# BULLETIN

## *PRODUCT SERVICES - Schaumburg*

Subject: MSR2000 and MSF5000 Ferro Resonant power supplies,  
TPN1185A, TPN1218A, TPN1184A, TPN1192A, TPN1226A, TPN1227A

# Product Services Bulletin

FIGURE 1 A

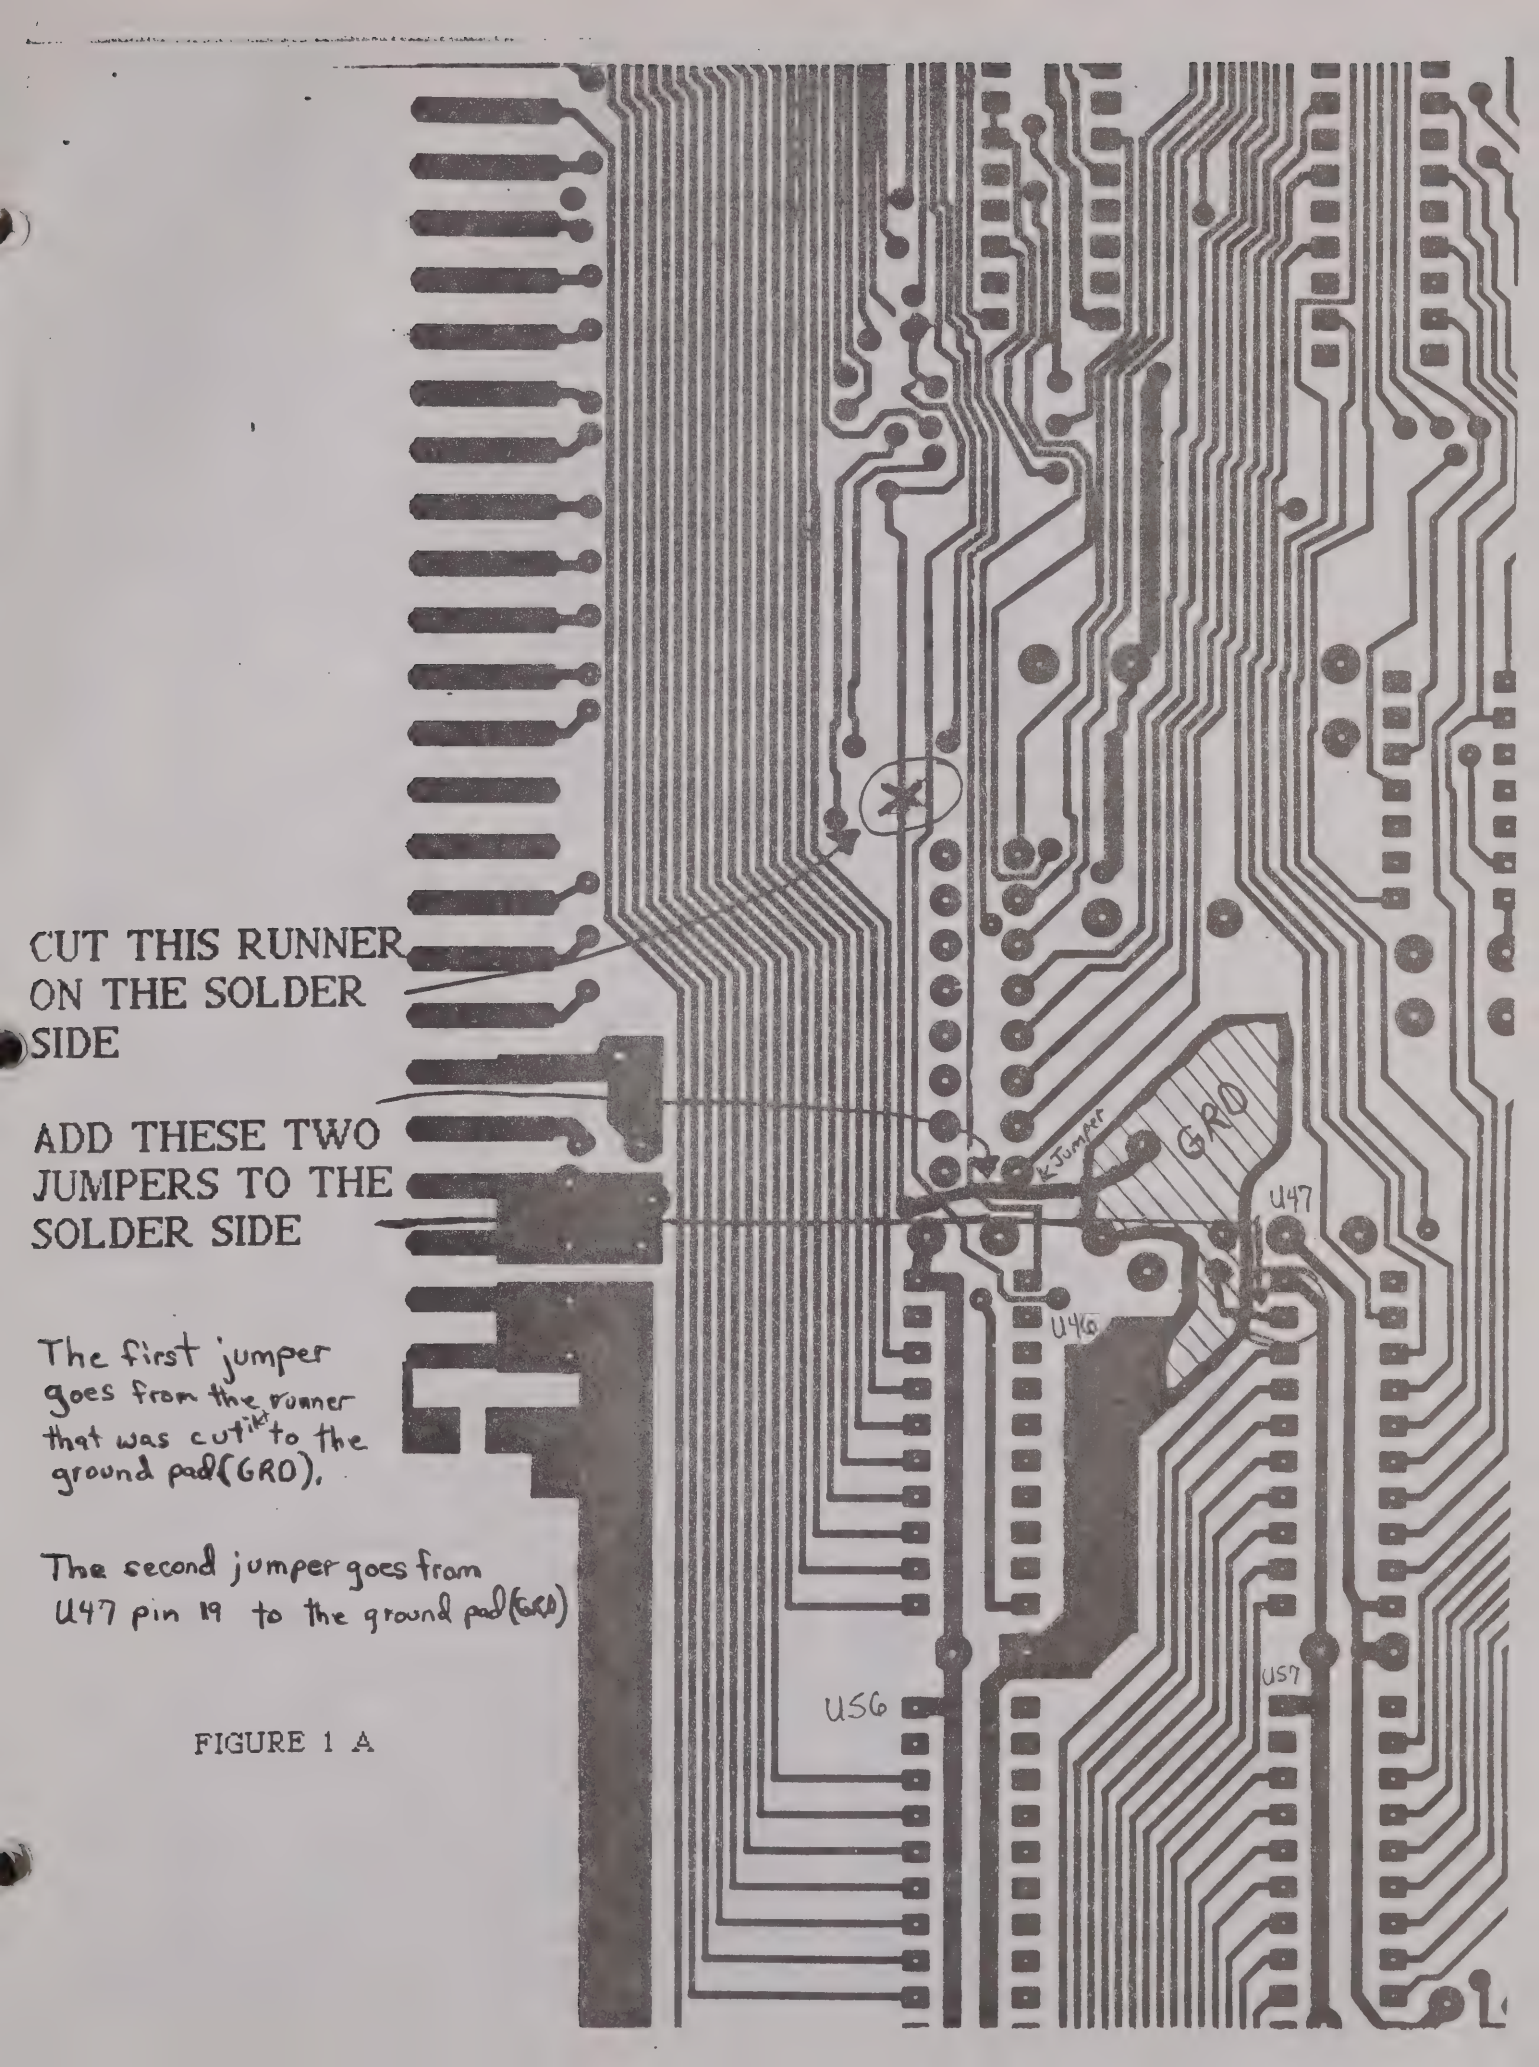
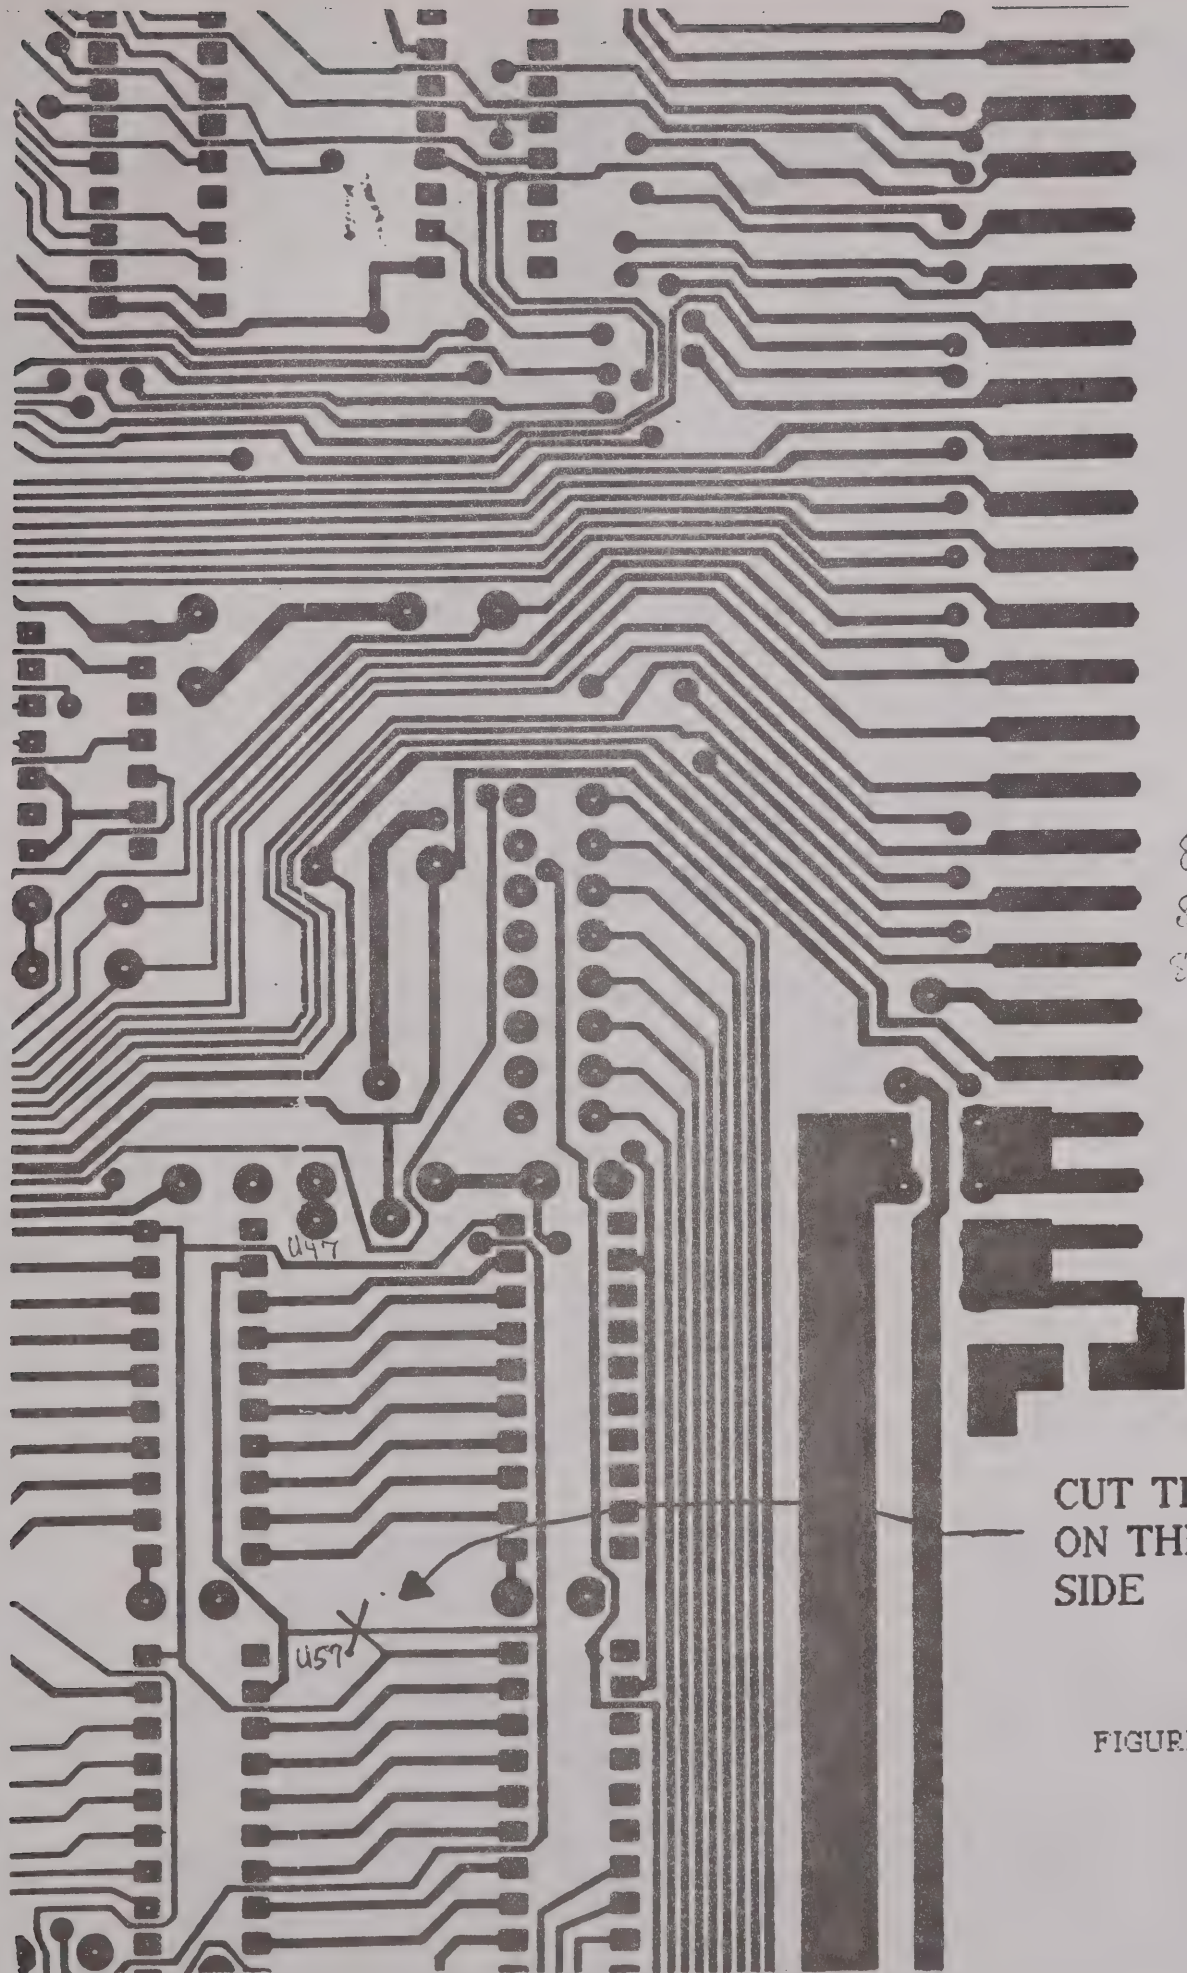
the U24 PAL (TRN9306A) should be removed and a 5184061P09 (TRN9306B) PAL installed. See figure 1 for the runner cuts and jumper instructions. See chart for PAL changes and part numbers.

Then you may want to make the runner cuts and add the two jumpers as shown in figure 1 to the MCB. Do NOT change the PAL on the MCB board.

If you have a Simulcast System then, it is recommended that the runner cuts be made and the two jumpers be added as shown in figure 1 for the DCB (TLN2788ASP09). You will also have to change the U24 PAL at the same time you make the cuts, and add the jumpers. Remove the U24 PAL on the DCB (TRN5726A) and install a 5184061P08 (TRN5726B) PAL. The ReSC09 board (TLN2788ASP08) should also have the runner cuts, add the two jumpers and a U24 PAL changed. Remove the U24 PAL (TRN9306A) and install a 5184061P09 (TRN9306B) PAL for the ReSC09.

If you have a TCI Console Interface board (TLN2788ASP10 or TLN2595ASP01) then you should make the runner cuts and add the two jumpers as shown in figure 1 for the TCI. You will also have to change U24 PAL at the same time you make the cuts and add the jumpers. Remove the U24 PAL (TRN5726A) from the TCI and install a 5184061P08 (TRN5726B) PAL.

Figure 2. Solder Side of I/O Trunk Board TRN6469A  
Showing Foil Cut Location (See Paragraph 1 for specific directions)

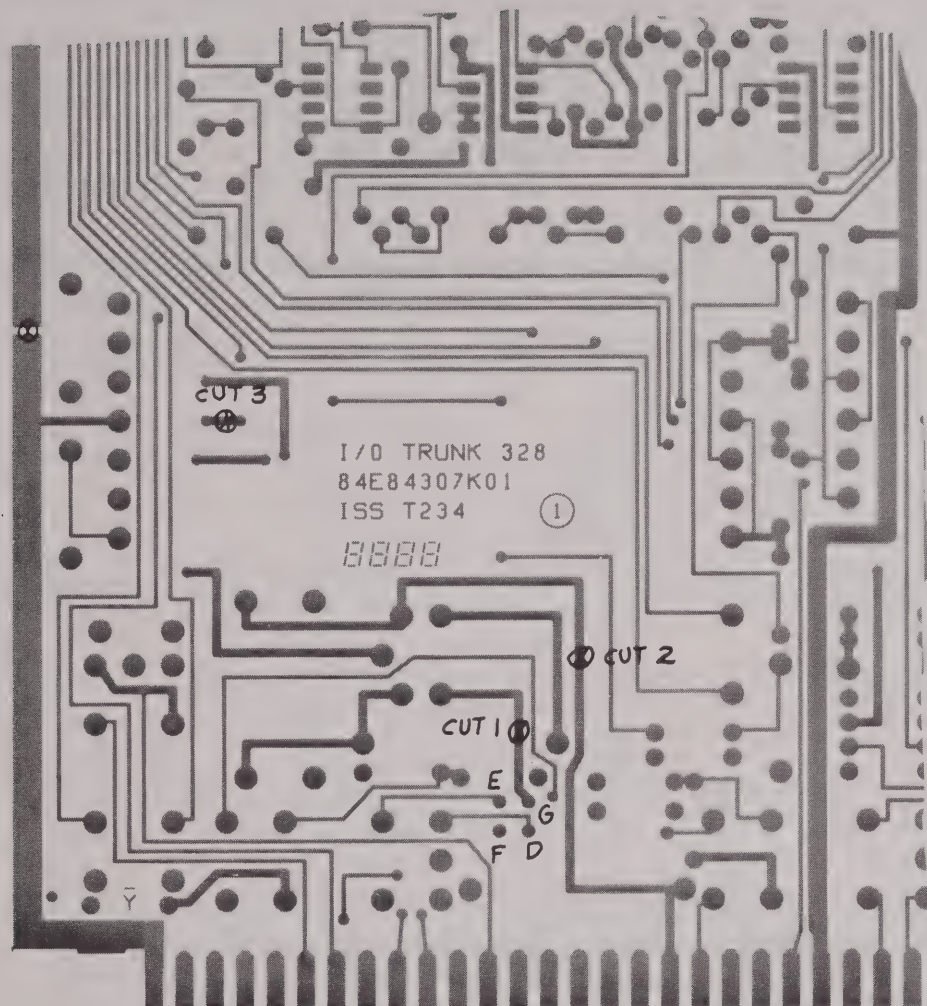
Using Figure 2 as a guide, make the following foil cuts on the copper side (i. e. non-component side) of the printed circuit board:

- (a) Terminals shipped before April 21, 1978 - cut #'s 1, 2 and 3.
- (b) Terminals shipped between April 21, 1978, and November 10, 1978 - cut #1 only.
- (c) Terminals shipped after November 10, 1978 - no cuts required.

Figure 3. Component Side of I/O Trunk Board TRN6469A  
Showing Jumper Location (See Paragraphs 2 and 3 for specific directions)

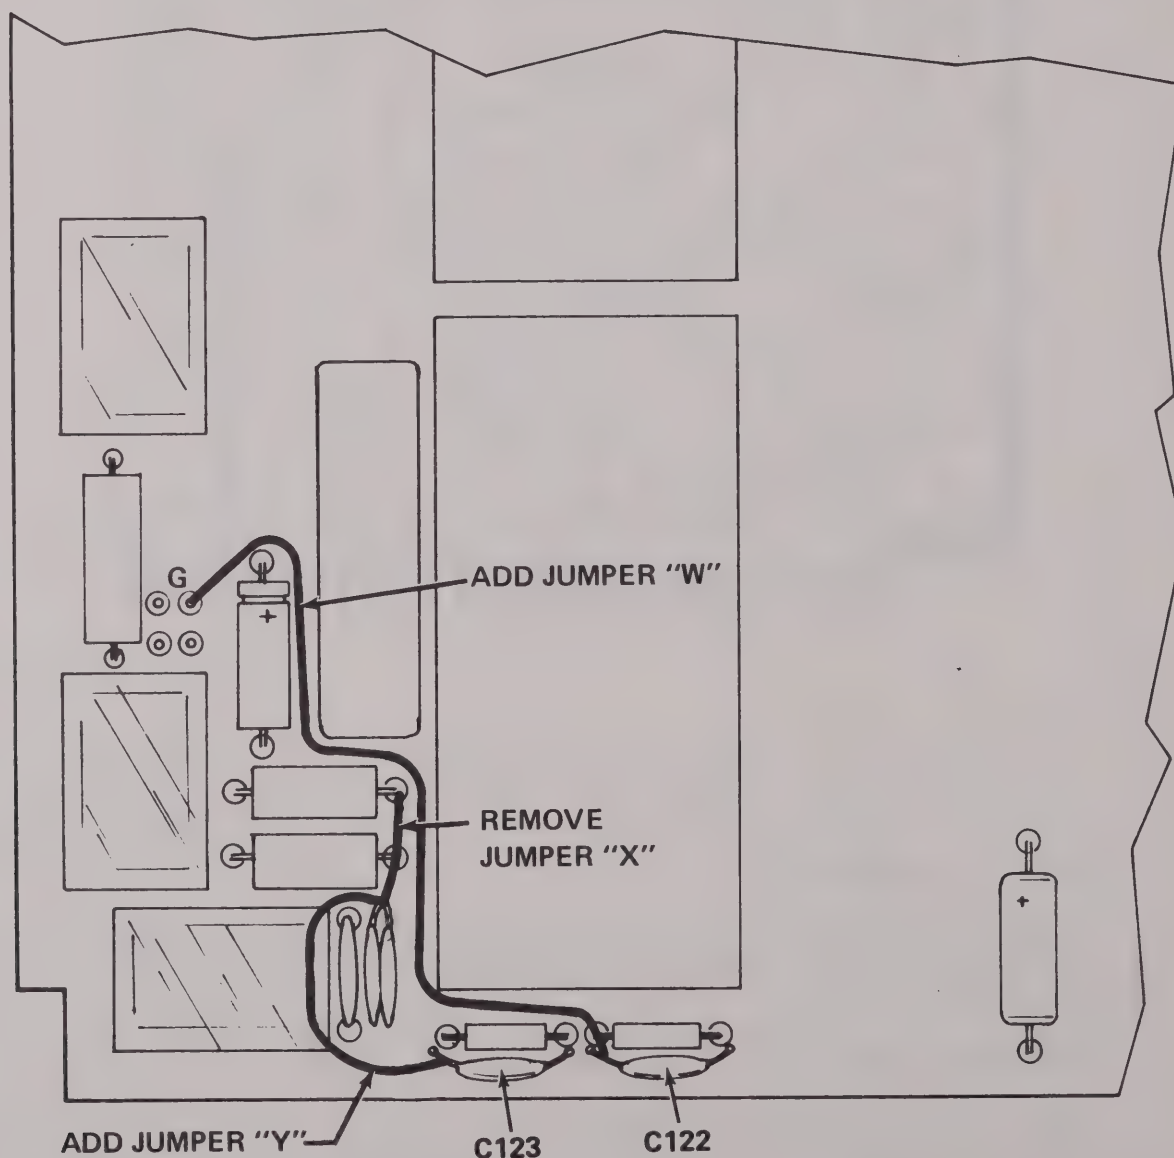
For only those terminals that shipped before April 21, 1978, remove jumper "X" as shown in Figure 3.

For all terminals shipped before November 10, 1978, add an insulated jumper wire (jumper "W") from programming Pin G to C122 as shown in Figure 3. The procedure for doing this is as follows:

- (a) Unwrap any wirewrap jumper which may be on Pin G.
- (b) Carefully solder jumper "W" on the component side of the board between the base of Pin G and C122 (i.e. communications ground "C"). Route the jumper as shown in Figure 3.
- (c) Reconnect the wirewrap jumper to Pin G that was removed in step (a).

For only those terminals that shipped before April 21, 1978, also add jumper "Y", as shown in Figure 3. Use insulated wire for the jumper.

Figure 4A. Component Side of I/O Trunk Board TRN6469A  
Showing Location of Resistors R300 and R301

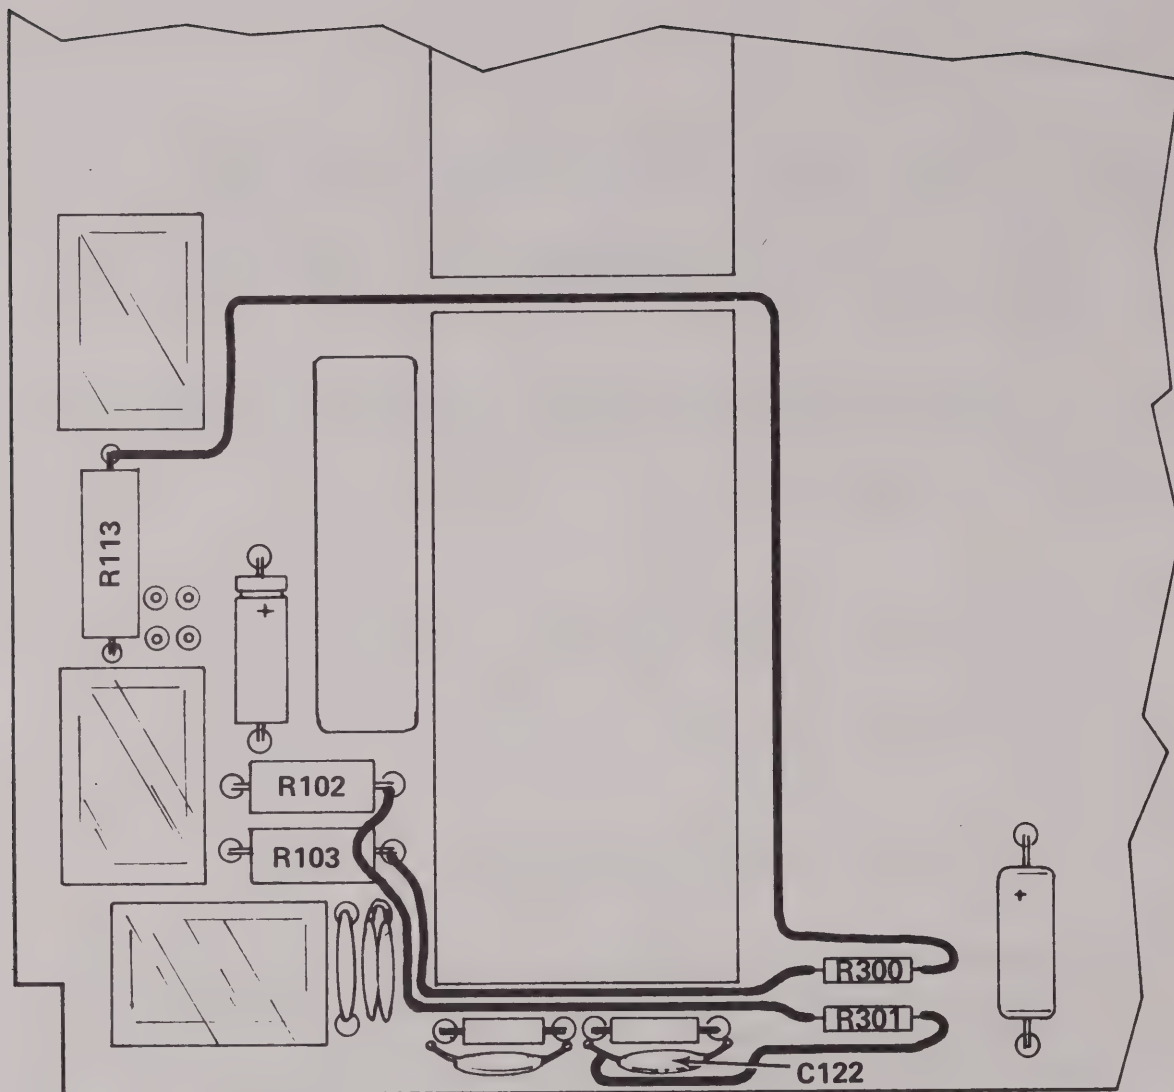
- (b) Connect the resistors as shown in Figure 4A. Note that all connections are made on the component side of the board. Route the resistor wires as shown, and epoxy the resistors to the board in the area shown, being careful not to make contact with other components. To make connections to resistors R102 and R103, it will be necessary to first unsolder these resistors, make the new connections, and then solder them back into the board.
